REBEL PROPERTY

SSDA BCA ASSESSMENT REPORT

164-172 and 174-194 William Street, Woolloomooloo

Date: 25 August 2025

3.1.2 BCA Clause S17C6: Sprinkler Valve Enclosure

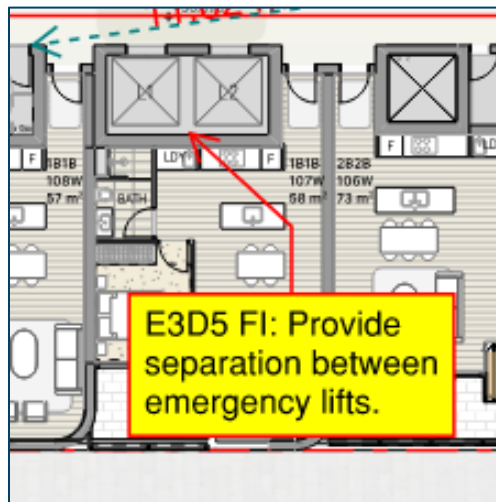
Architect and Fire Services consultant to confirm where the sprinkler valve enclosure is located within the building.
